APPENDIX D COMMENT RESPONSE TABLES AND OTHER PPRP AND OBSERVER FEEDBACK

PPRP Comment Response Table

NRC (Observer) Comment Response Table

Jeffrey Kimball (Observer) Comment Response Table

Magnitude Scaling by Cluster: 1 Hz

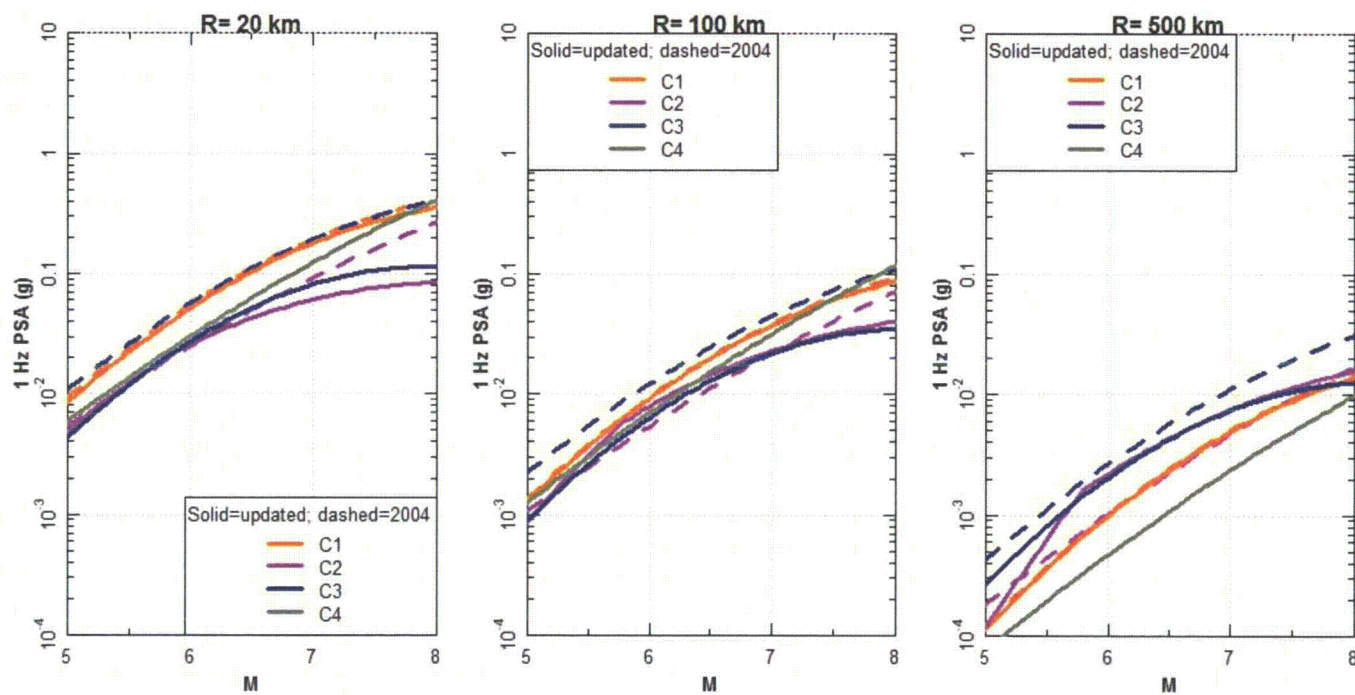
4. In Figure 8.4, add curves for M 3 and M 4 to cover the magnitude range where the majority of data are.	Curves for M 4 added.

Effect of Always Using OK-AR Data – Cluster Weights

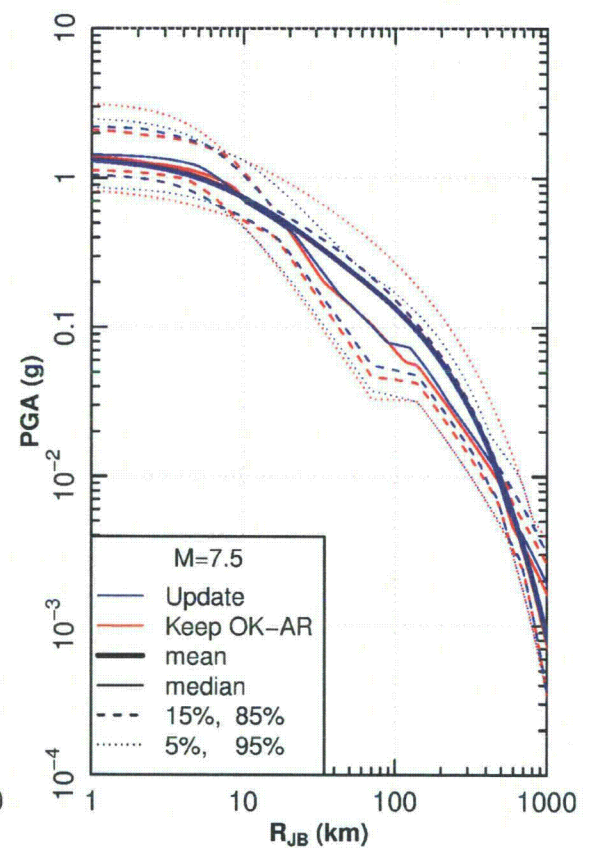
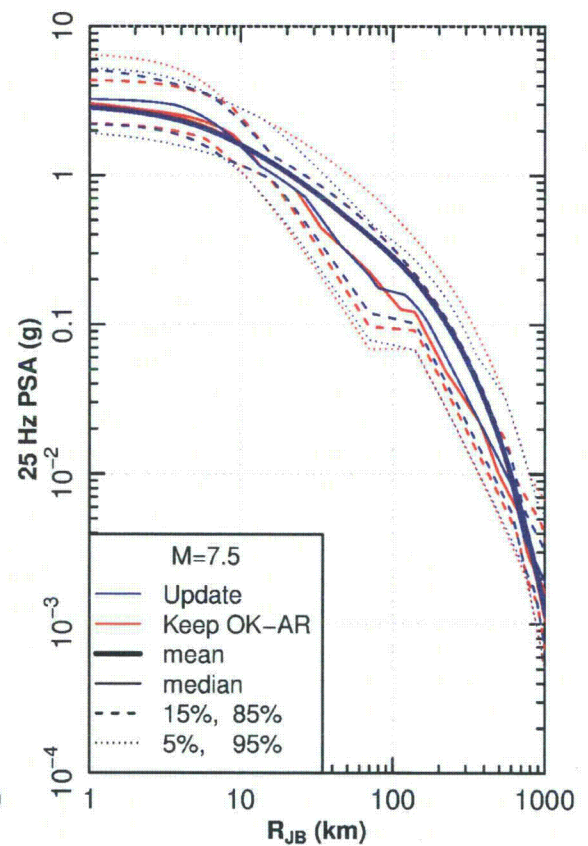
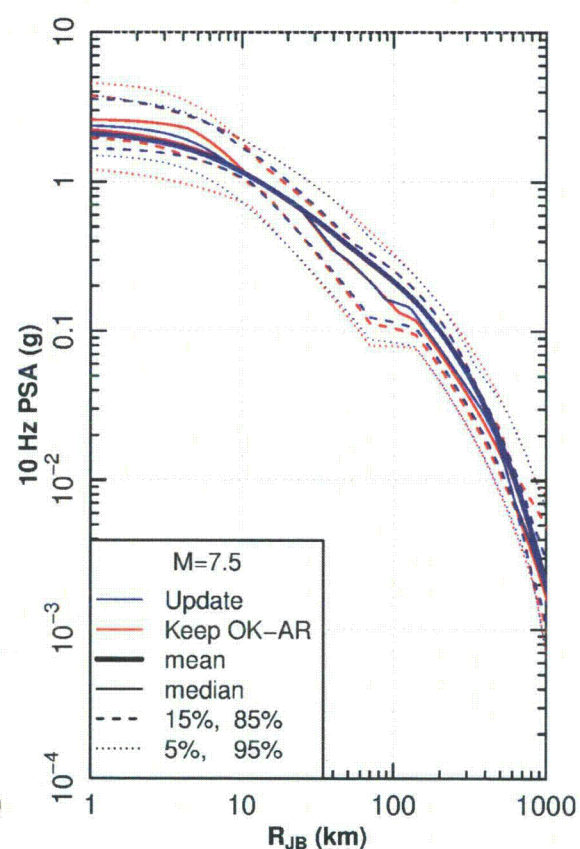
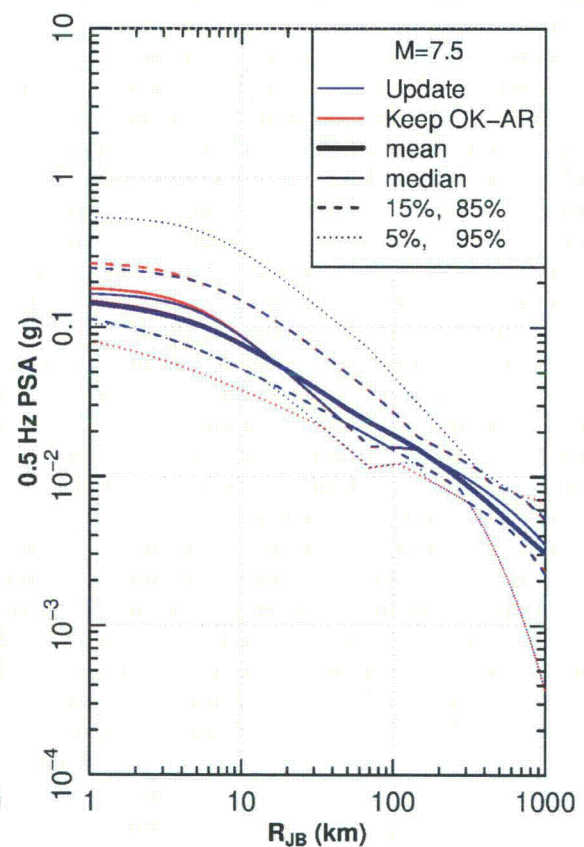
<p>5. Some examples of response spectra from both the updated GMM and the 2004-2006 EPRI GMM</p>	<p>Some examples of response spectra from both the updated GMM and the 2004-2006 EPRI GMM were presented in the PPRP Closure Briefing on February 13, 2013. See Slides 204, 205, 206 and 207.</p>
<p>6. Provide a more in-depth discussion of the decision to consider the OK-AR earthquake ground motion data as possibly “anomalous” and the impact of that decision on the results. Information provided might include:</p> <ul style="list-style-type: none"> • Review of the reasons for considering those data are not typical • Why there is some weight given to the interpretation that those data are not part of the suite of ground motions the updated GMM is intended to predict. • What portion of the overall data set the earthquakes comprise. • Has the database been examined to determine if any other of the earthquakes or regions are anomalous in a sense similar to that for the OK-AR events (depth, stress parameter, kappa)? • Review the impact on the interim and final results • Review the technical basis for the weights given to inclusion or exclusion of those data. 	<p>An expanded discussion of the effect of always using OK-AR Data for frequencies of 0.5 Hz, 2.5 Hz, 5 Hz, 10 Hz, 25 Hz and PGA was presented in the PPRP Closure Briefing on February 13, 2013. See Slides 148-154. The effect of always using OK-AR Data on cluster weights is shown on Slide 147.</p> <p>As part of completion of the model, the effect of the OK-AR data will be examined using all candidate models. We will also check SE Canada versus the rest of the US (excluding OK-AR).</p>
